SUBJECT: RESEARCH INFORMATION LETTER #17 - POWER BURST FACILITY
(PBF) SINGLE ROD POWER-COOLING MISMATCH (PCM) TEST
RESULTS

ERRATA TO TREE-NUREG-1196, "RESPONSE OF UNIRRADIATED AND IRRADIATED
PWR FUEL RODS TESTED UNDER POWER-COOLING-MISMATCH CONDITIONS" - Zan-70-78

On Page 5, Figure 2 is deleted and replaced with the one below.

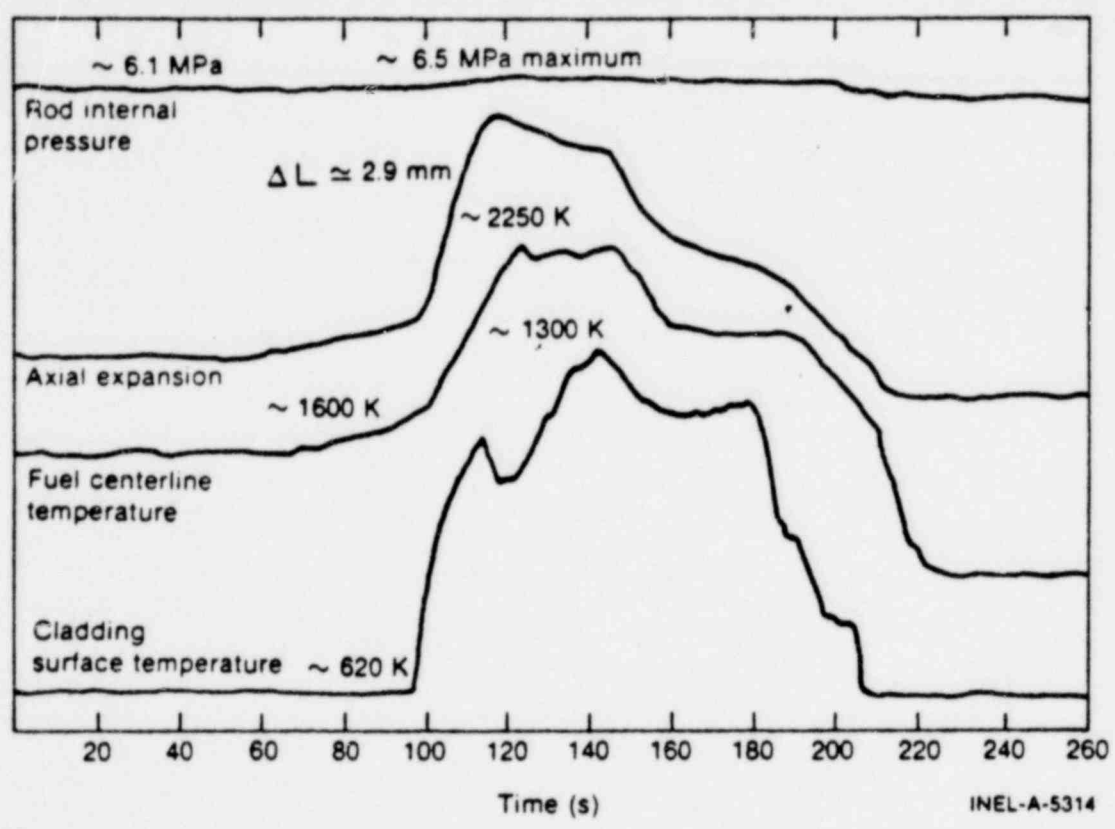
1. On Page 5, para. 2, sentence 3, change ". . . 600 to 1680 K." to ". . . 900 to 1850 K."
2. On Page 5, delete Figure 2 and insert the attachment.
3. On Page 7, Table III, column 9, "Coolant Mass Flux for DNB (kg/s-m²)," change the last four numbers from 1190, 1210, 1100, and 1265 to 1275, 1315, 1210, and 1800, respectively.
